Ward Park Improvements

ADDENDUM NO. 3

August 27, 2014

ISSUED BY: Office of the City Engineer
Department of Public Works
Administrative Offices – 2nd Floor
135 Neil Street
Marlborough, MA 01752

PRECAST CONCRETE DRAIN MANHOLE

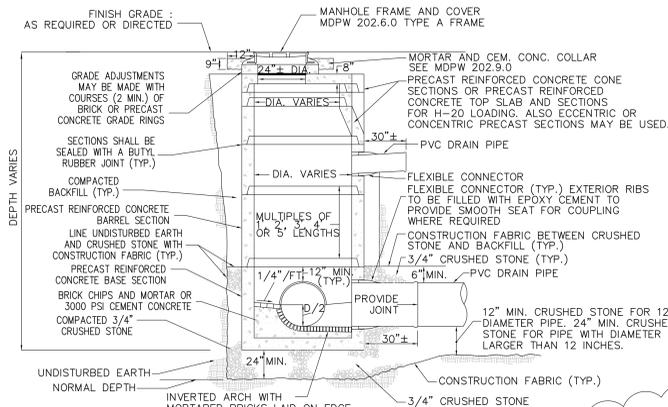
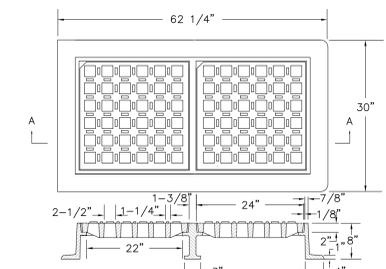
7. DMH #5 is labeled as an 8' CB on with detail 4/L-9. Should this be labeled as an 8' DMH with Detail S/L 9?

Response: Refer to the revised Sheet L-5 included herein.

DETAIL 10 NOT TO SCALE L-9

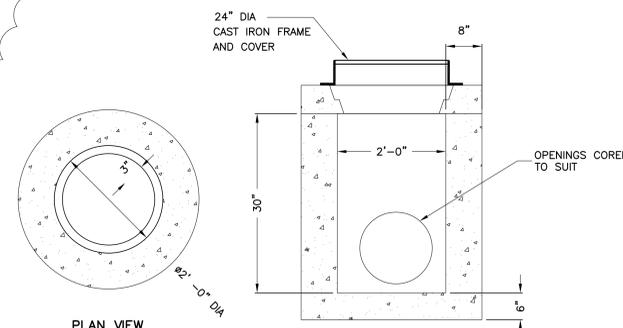
10. Is the collector drain pipe 6" or 15" diameter? The detail 10/L-9 has labels showing both size pipes.

Response: 15"

HDPE YARD DRAIN

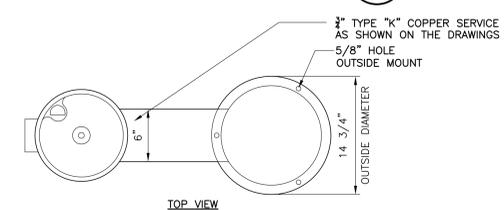
8. What size are the Yard Drains? No dimension on detail or plans.

Response: 12"

WATER FOUNTAIN

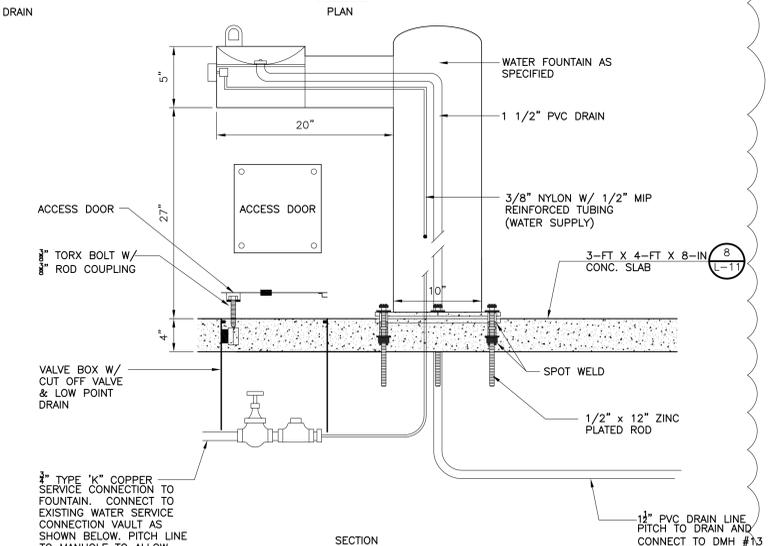
5. SECTION 02850 **ADD** Paragraph 2.12 and 3.12 as follows:

- A. Contractor shall furnish and install one (1) drinking fountain, Series 440SM by Most Dependable Fountains, Inc. of Arlington, TN, tel: (800) 867-0039.

- A. Coordinate and schedule all work for installation of the drinking fountain water service with Owner.
- B. Install Drinking fountain on concrete pad in location shown on the Drawings. Stake location for approval by Engineer.

DETAILS VII - RESTROOM BUILDING PLAN AND SECTIONS

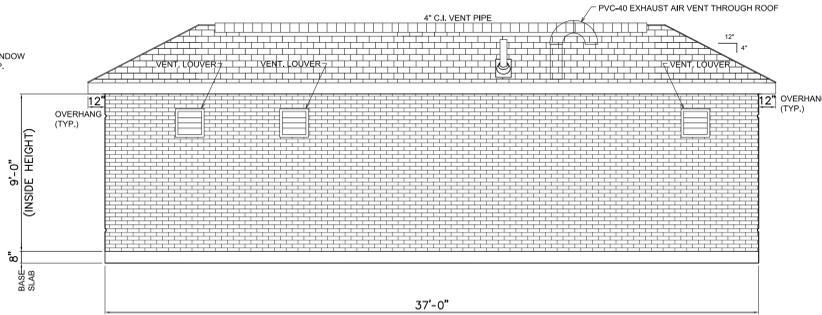
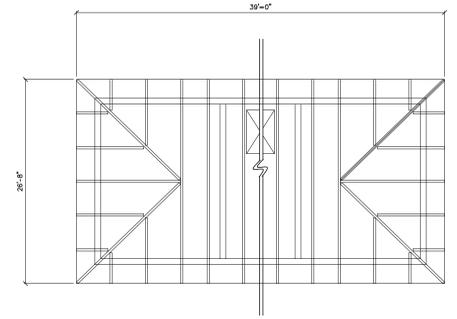
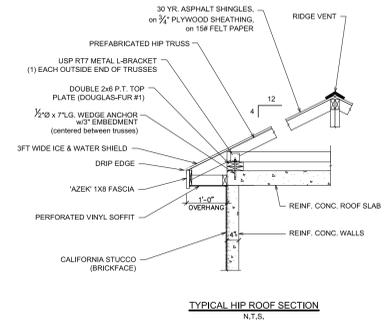
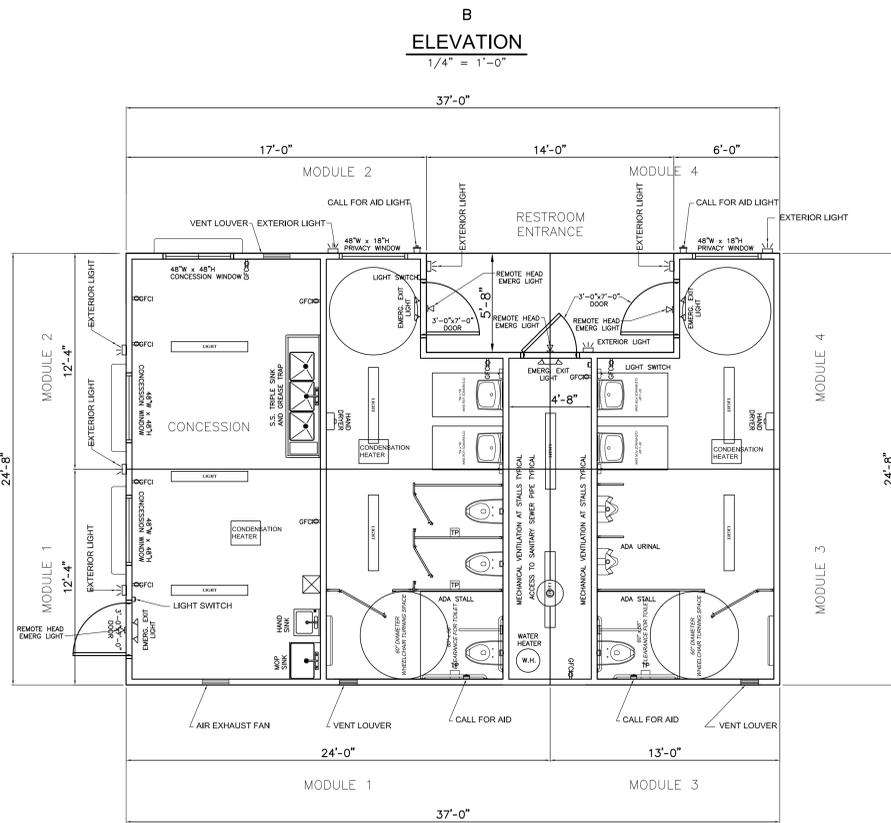
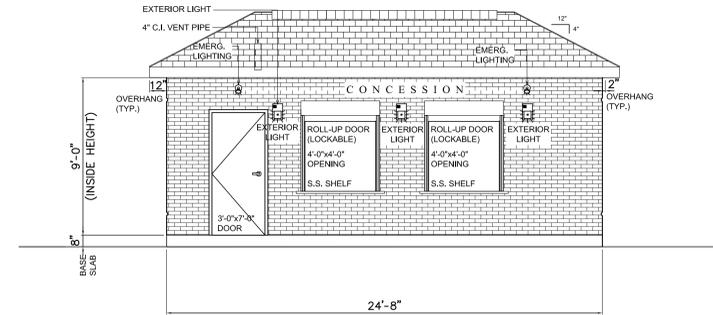
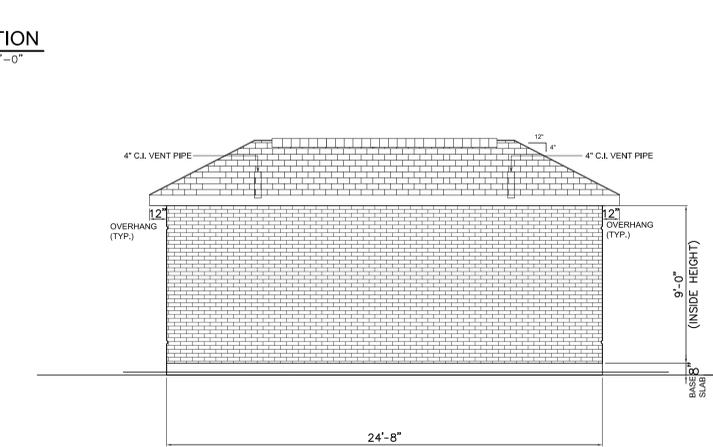
REV. NO.	DATE	DRWN	CHKD	REMARKS
1	8.26.14	DAM	SWL	REVISED THE ROOF LINE TO ADD A HIP ROOF

BASKETBALL/ VOLLEY COURT PAVEMENT EDGE

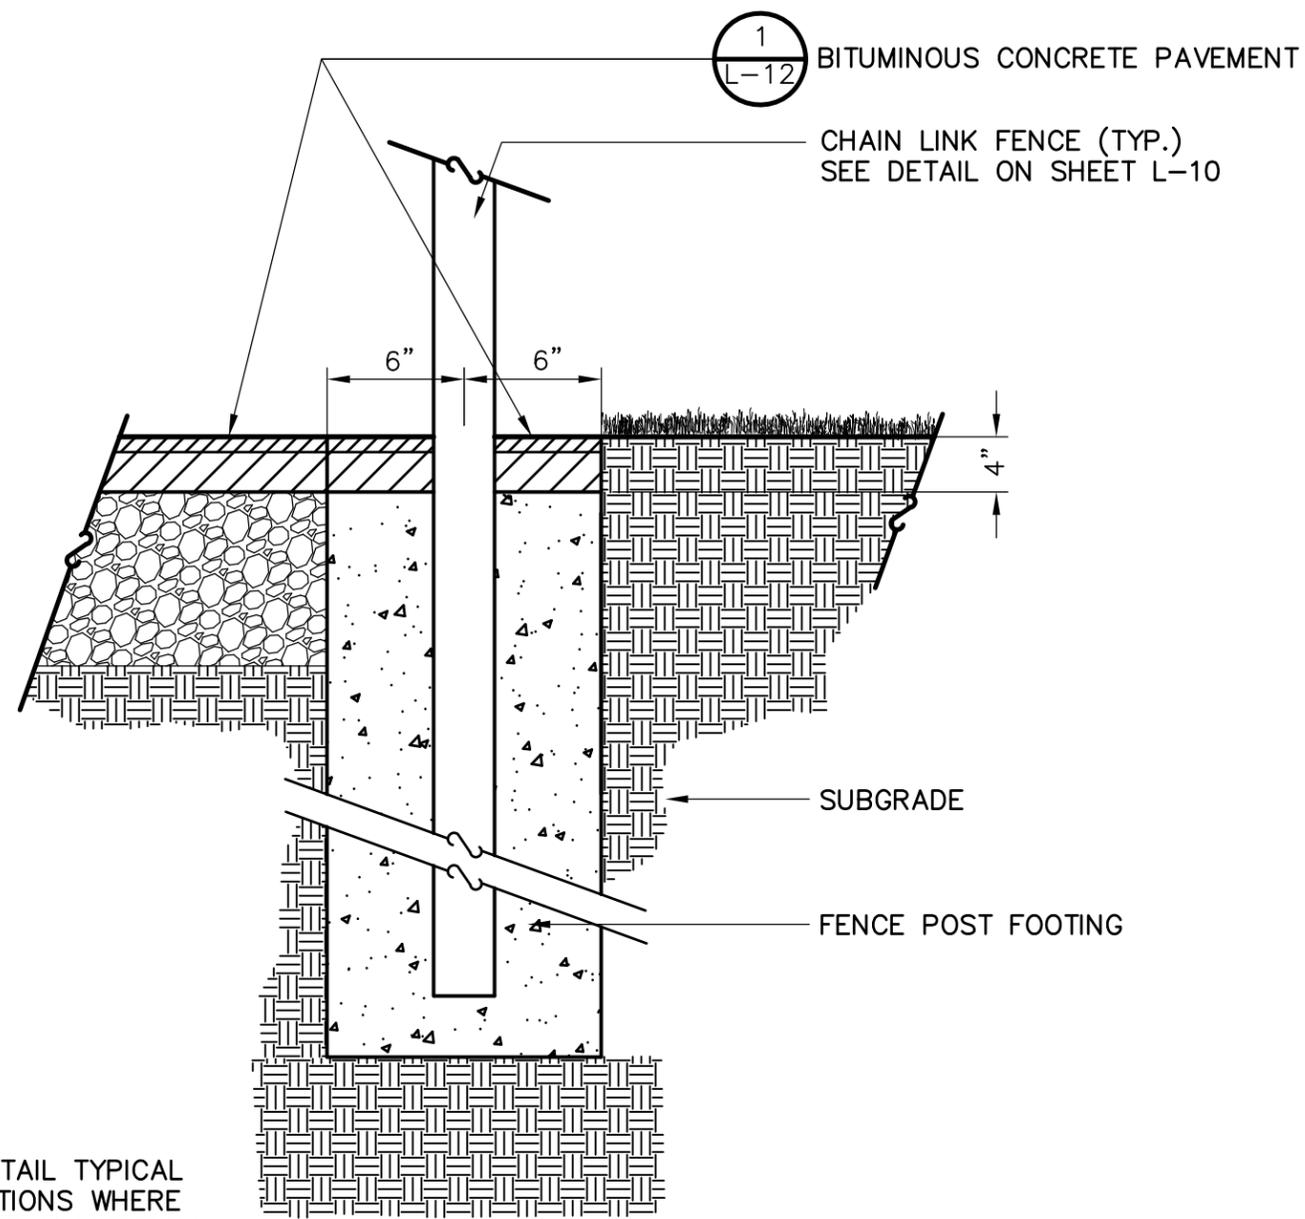
29. Please confirm that the chain link fence with a mow strip is only along the west side of the skate park, around the entire pool area, and along the north side of the athletic field.

Response: Refer to the revised pavement edge detail on SK-1. There will be no concrete mow strip along this edge. Bituminous pavement shall be placed over concrete footings to provide continuous surface 6" past fence posts.

BENCH LOCATIONS

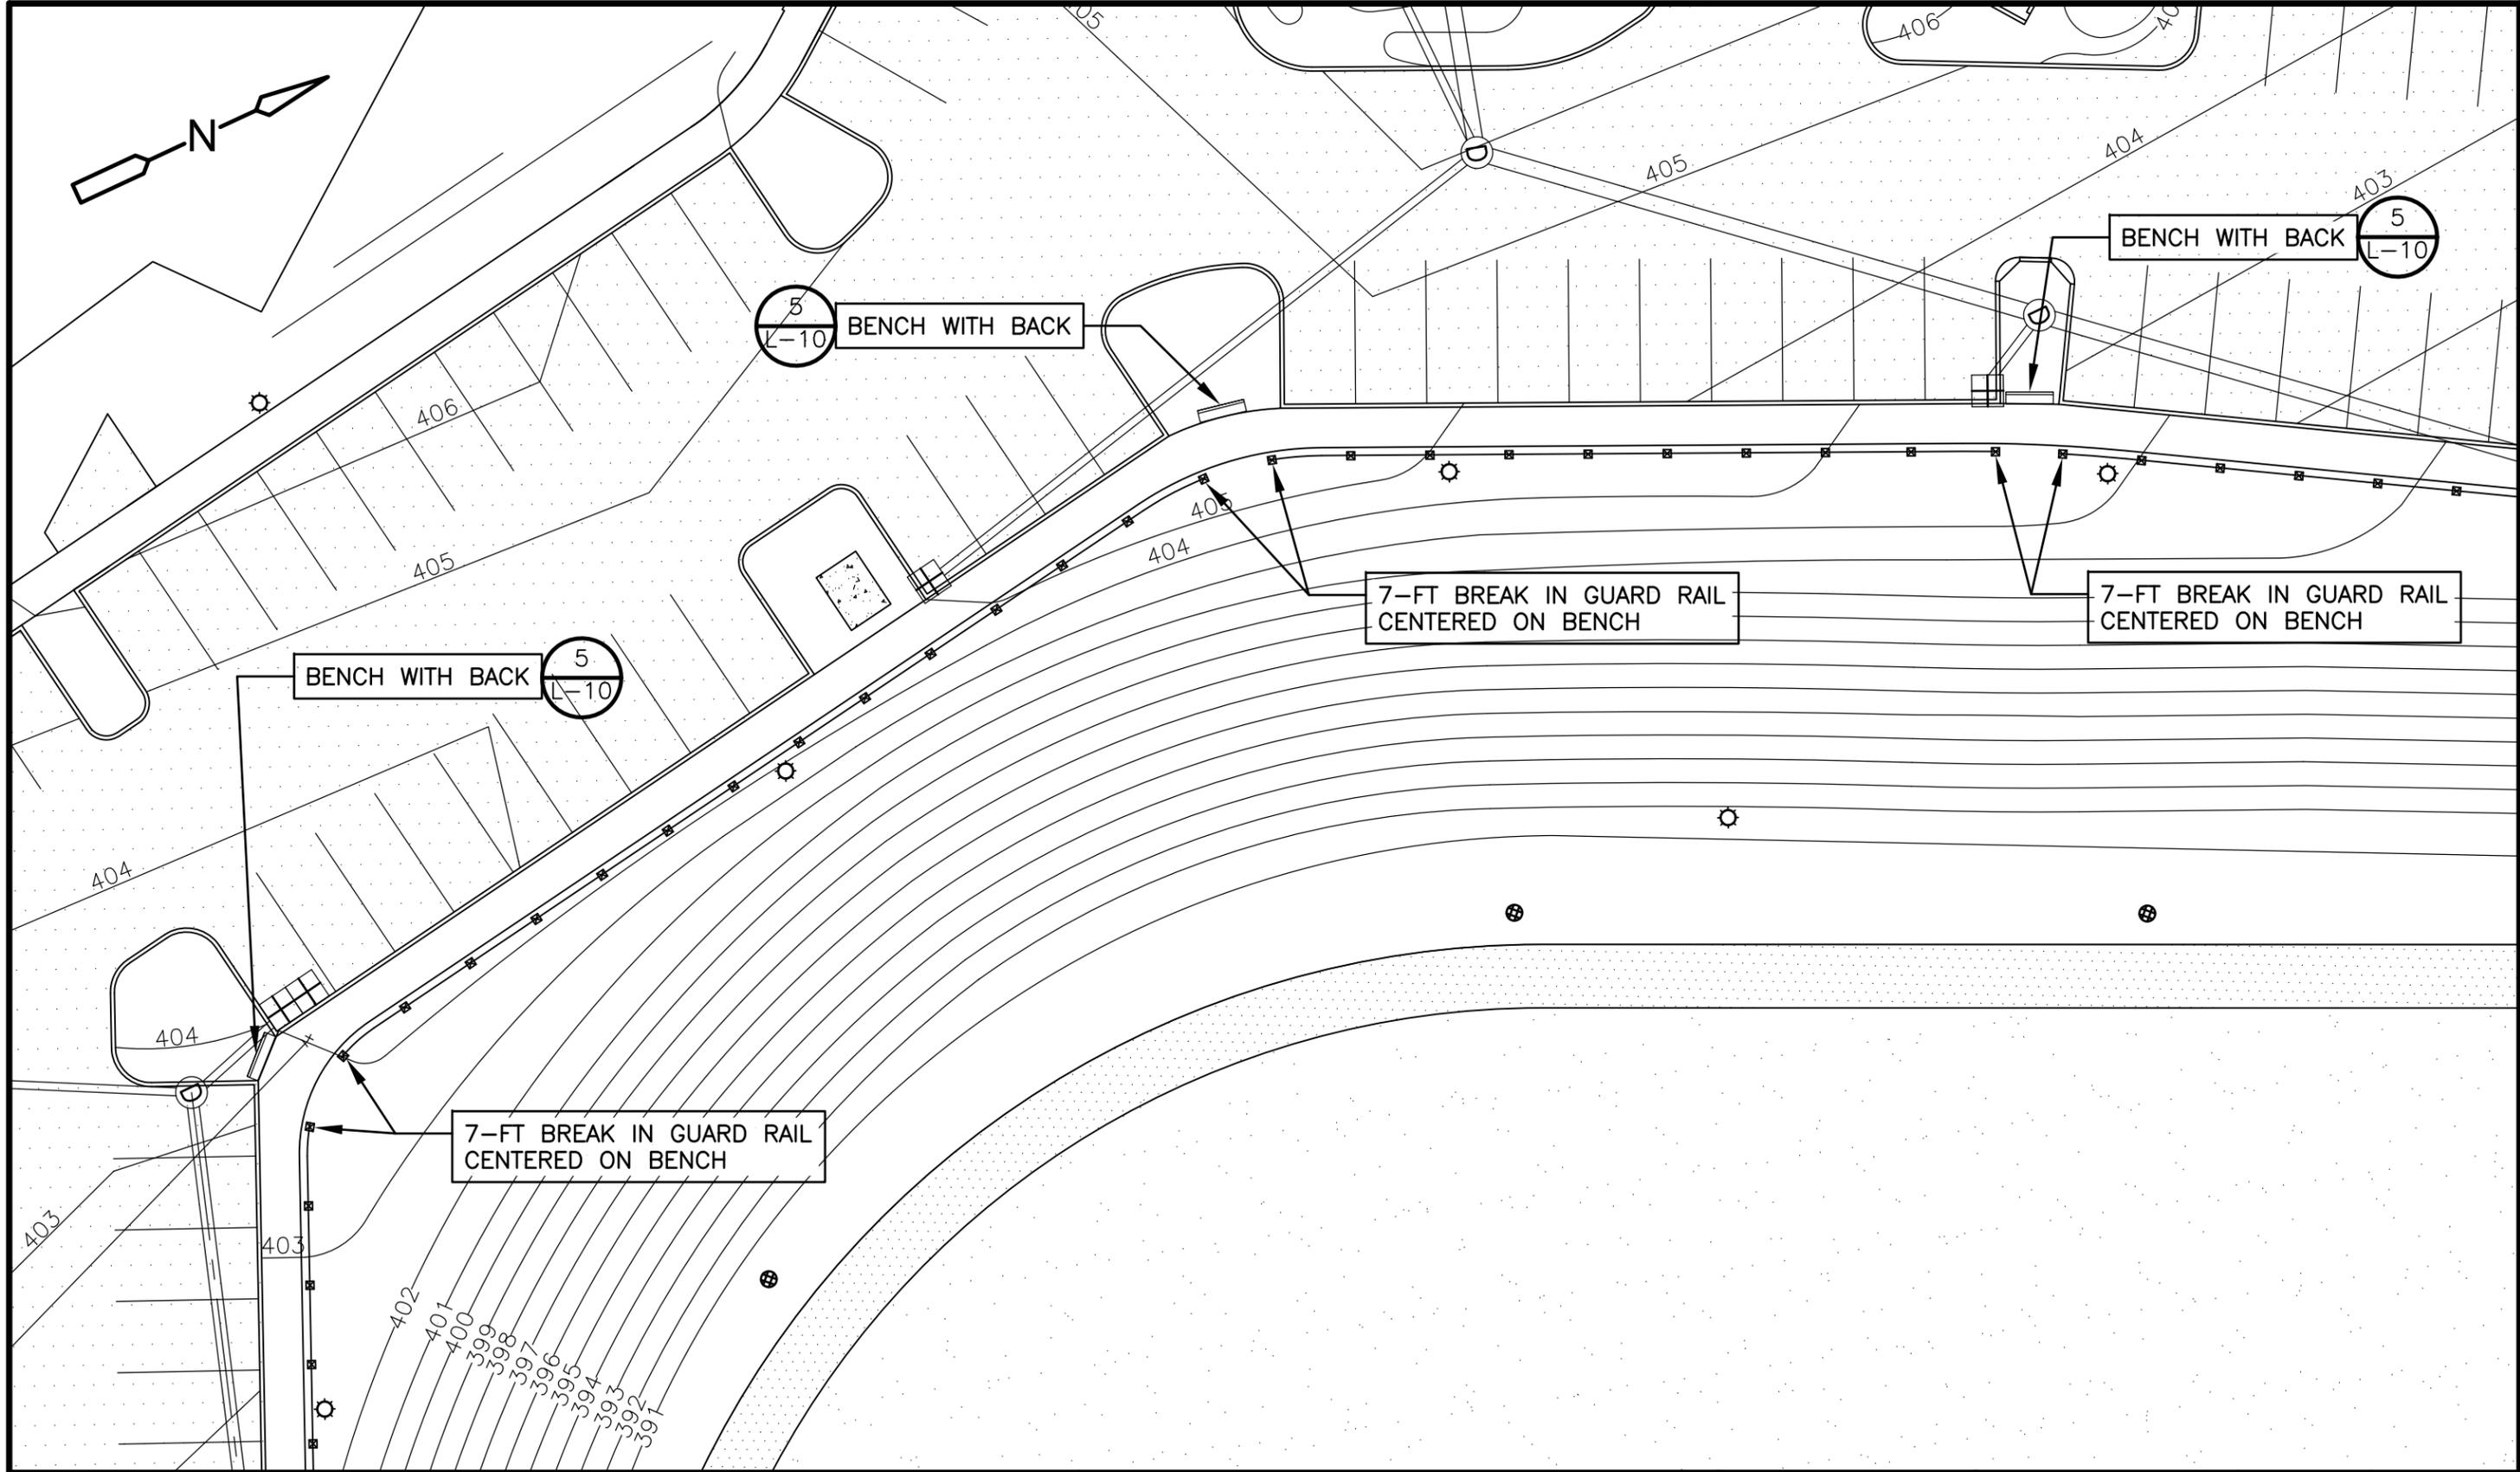
1. On Sheet L-2, revise the sheet references FROM sheet L-5 TO L-8.
2. On Sheet L-2, DELETE note "Hybrid Basketball".
3. REPLACE Sheet L-4 with revised Sheet L-4 as included herein.
4. REPLACE Sheet L-5 with revised Sheet L-5 as included herein.
5. REPLACE Sheet L-6 with revised Sheet L-6 as included herein.
6. REPLACE Sheet L-7 with revised Sheet L-7 as included herein.
7. REPLACE Sheet L-8 with revised Sheet L-8 as included herein.
8. REPLACE Sheet L-9 with revised Sheet L-9 as included herein.
9. REPLACE Sheet L-14 with revised Sheet L-14 as included herein.
10. REPLACE Sheet L-15 with revised Sheet L-15 as included herein.
11. ADD SK-1 as included herein to INSERT Detail 10/ L-10 and REVISE Detail 8/ L-12 .
12. ADD SK-2 as included herein to INSERT Detail 13/ L-9.
13. ADD SK-3 as included herein for revised notes to SHEET L-3.
